CURRAGH RESOURCES INC.
DETAILED WASTE ROCK MANAGEMENT PLAN
FARO DEPOSIT
OCTOBER 1987

Review of Detailed Waste Rock Management Plan

from Joan Eamer

November 18, 1987

FIGURE I.

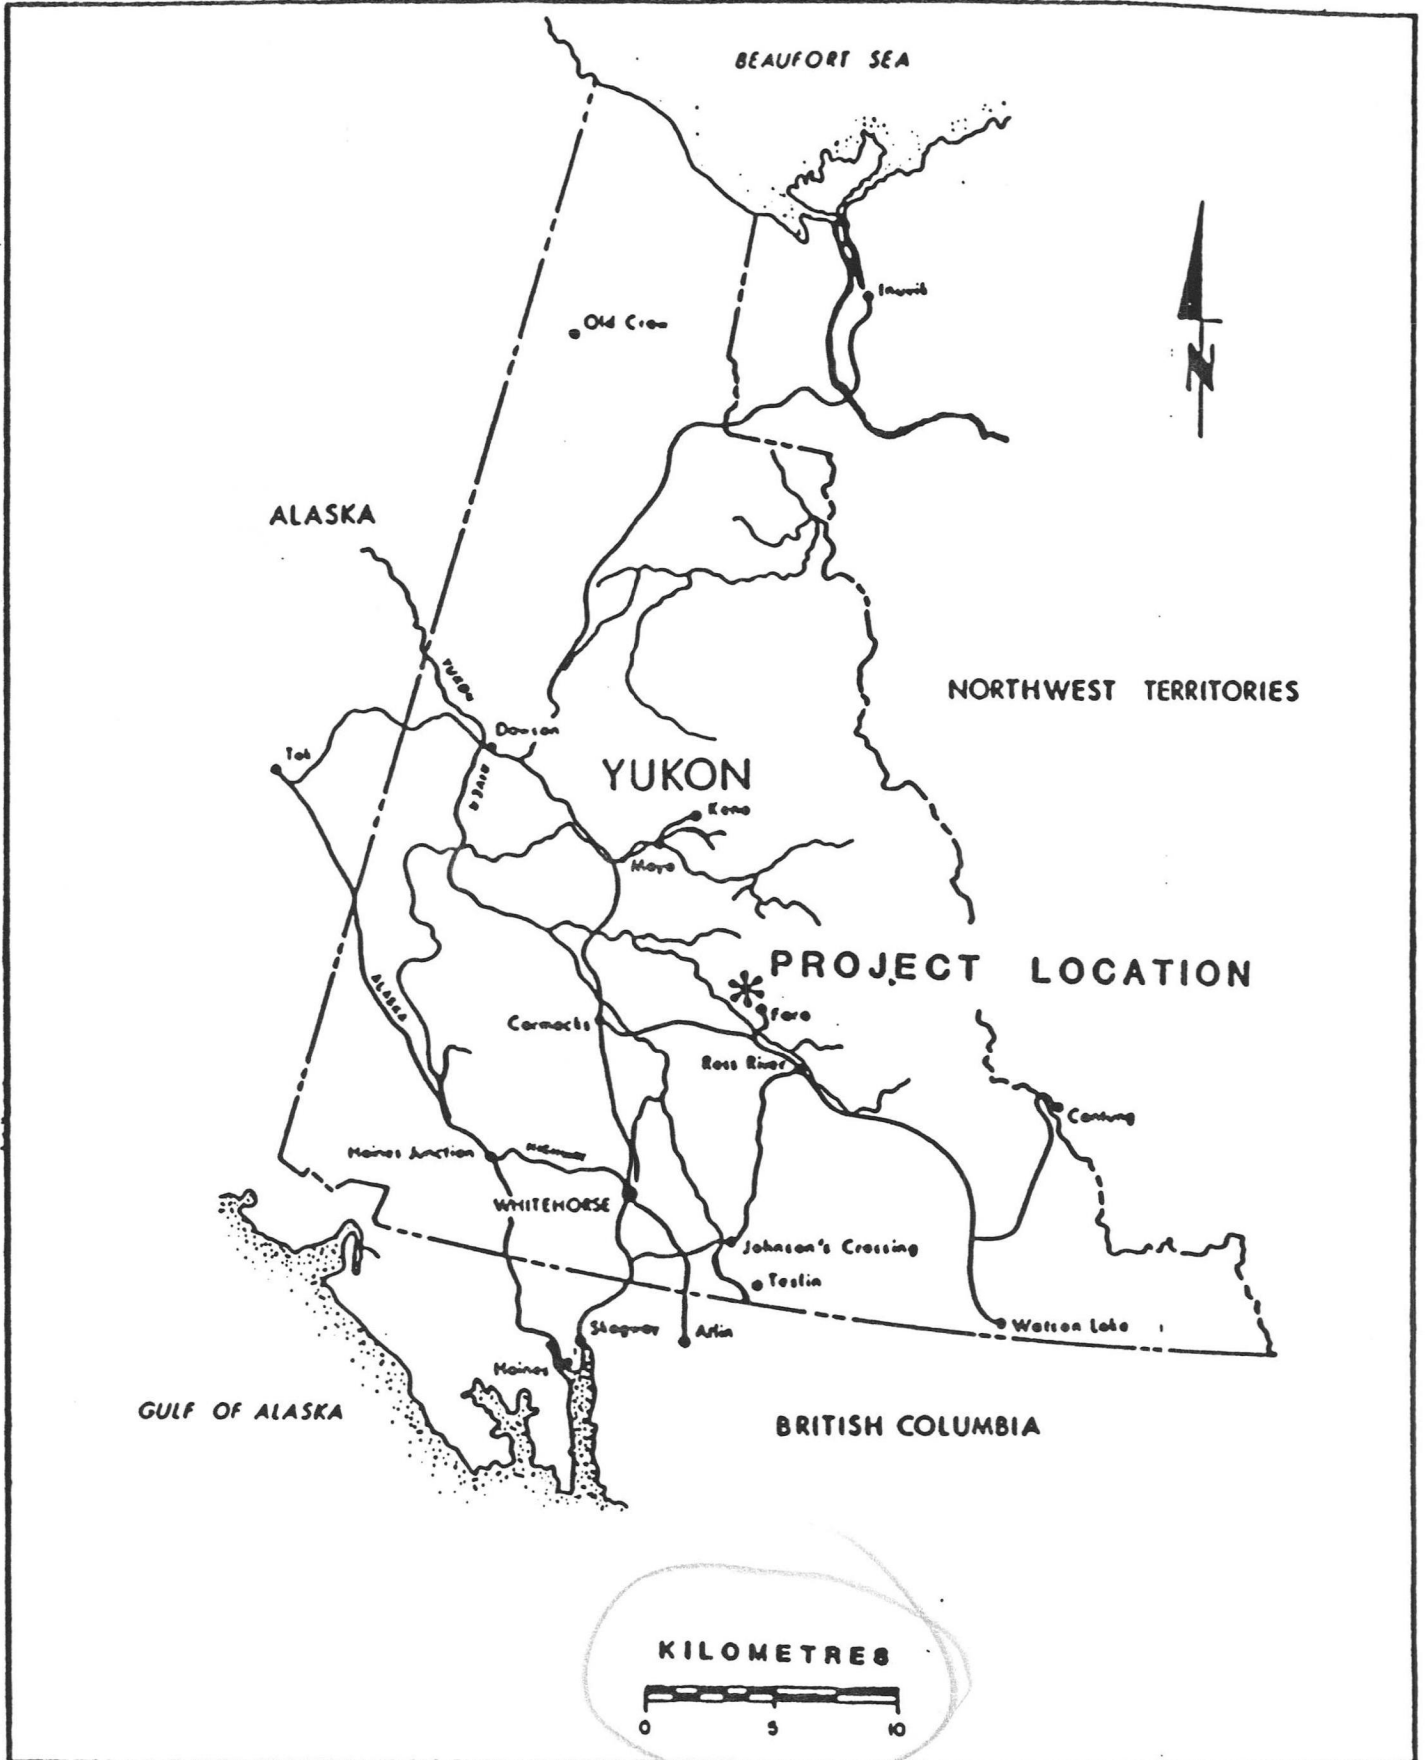
Is Figure 1 necessary? If it is used, the scale should be corrected (I wish Faro were that close to Whitehorse!)

FIGURE 2. MAIN WASTE DUMP PROFILE

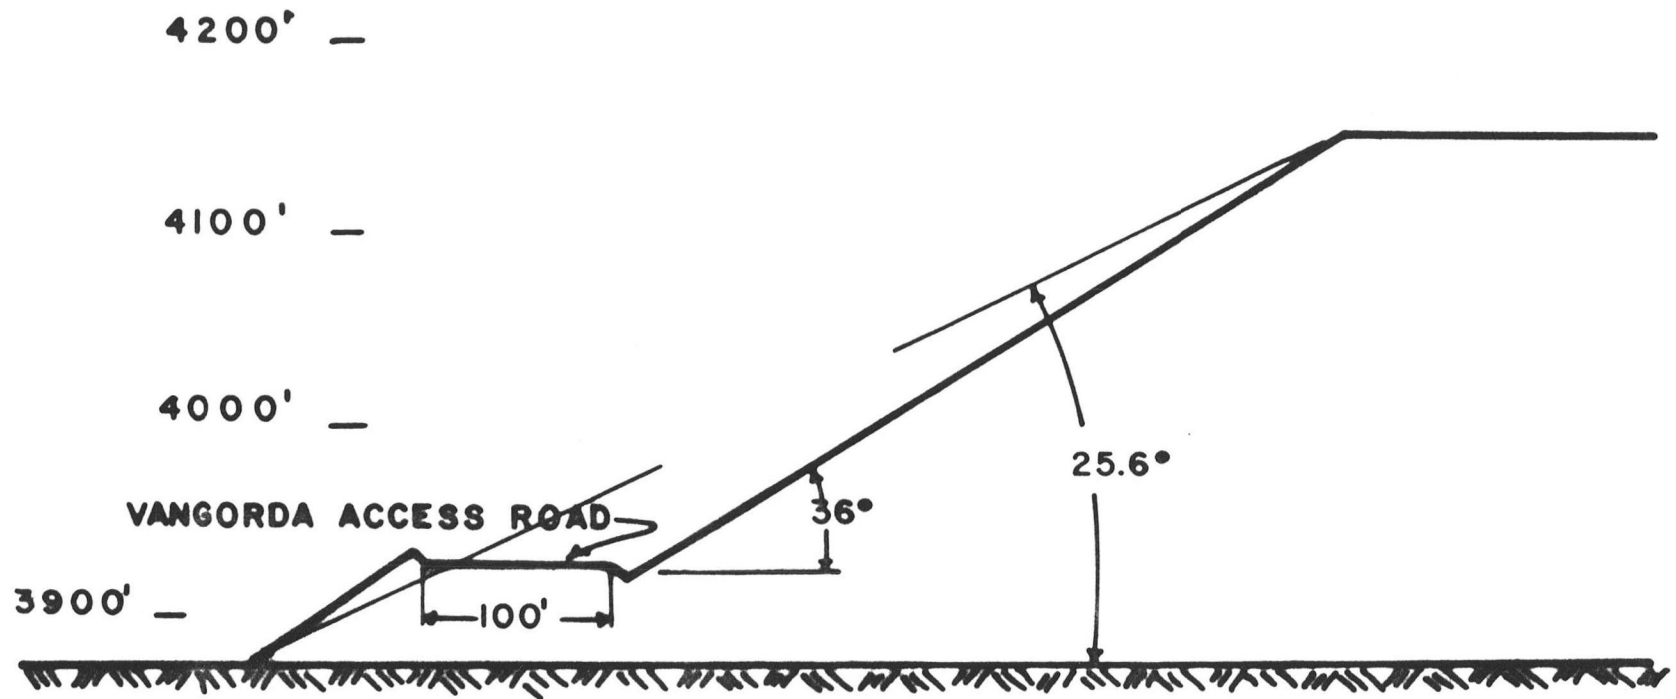
If the "overall slope" of the new dumps is 2:1, but the actual slope of the rock is steeper, is the waste rock in benches? How wide and high are the benches? Figure 2 would indicate that there are no benches, just the road width to achieve the 2:1 slope. What about dumps that the road does not intersect? Have the dump profiles shown in Figure 1 of the old plan been followed? What will the slope be on the Vangorda Access Road, particularly in the North Fork valley?
